Access Compliance Report

Public Rights-of-Way

(Curb Ramps)

Intersection ID: 10011359	Main Street: COCHRANE_DR	Cross Street: N/A	Location:	N
ADA ID: ABA15E5F42B3	Ramp Type: Perp	Initial Pass/Fail: Pass	Overall Compliance: No	Severity Score: 5.25
Codes/Mitigation Info/Possible Solution		Field Measurements/Component Compliance

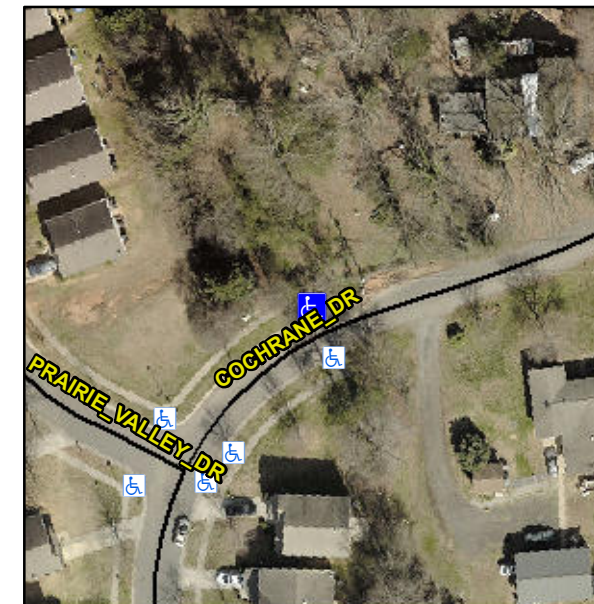
Not Found, R304.2.2-Perp, R304.3.2-Para, R304.5.4

Compliance	Description	Data	Compliance	Description	Data
N/A	Ramp Length (in)	84.0	Yes	Ramp Slope (%)	5.3
Yes	Ramp Width (in)	48.0	Yes	Ramp XSlope (%)	2.8
N/A	Flare Type LT	Sloped	N/A	Flare Type RT	N/A
N/A	Flare Slope LT (%)	2.4	N/A	Flare Slope RT (%)	9.2
N/A	Flare Traversable LT?	No	N/A	Flare Traversable RT?	No
Yes	Landing Length (in)	48.0	Yes	DWS Provided?	Yes
Yes	Landing Width (in)	48.0	Yes	DWS Contrast?	Yes
No	Landing Slope (%)	4.3	Yes	DWS Length (in)	24.0
Yes	Landing X Slope (%)	4.0	Yes	DWS Full Width?	Yes
N/A	Landing Curb? (Y/N)	No	Yes	DWS Offset (in)	0.0
N/A	Shared Landing?	No			
Yes	Gutter Ponding?	No	No	Gutter Slope (%)	9.8
Yes	Gutter Lip Ht (in)	0.0	Yes	Gutter X Slope (%)	4.2
N/A	Painted X Walk1?	No	N/A	Painted X Walk2?	N/A
	X Walk 1 Direction	To S		X Walk 2 Direction	N/A
N/A	X Walk 1 Width (in)	N/A	N/A	X Walk 2 Width (in)	N/A
	X Walk 1 Slope (%)	5.8		X Walk 2 Slope (%)	N/A
	X Walk 1 X Slope (%)	4.6		X Walk 2 X Slope (%)	N/A

N/A	Ramp inside XWalk1?	N/A	N/A	Ramp inside XWalk2?	N/A
	Road Slope (%)	N/A	N/A	Clear Space?	Yes
	Road X Slope (%)	N/A	N/A	Clear Space to XWalk (in)	N/A
Yes	Any Obstructions?	No	Yes	Storm Grate/Utility Hazard?	No
	Obstruction Type			Storm Grate/Utility Type	
		N/A			N/A
			Yes	Surface Condition? (G/P)	Good

**Remove & Replace Entire Ramp.
Remove & Replace Gutter.**
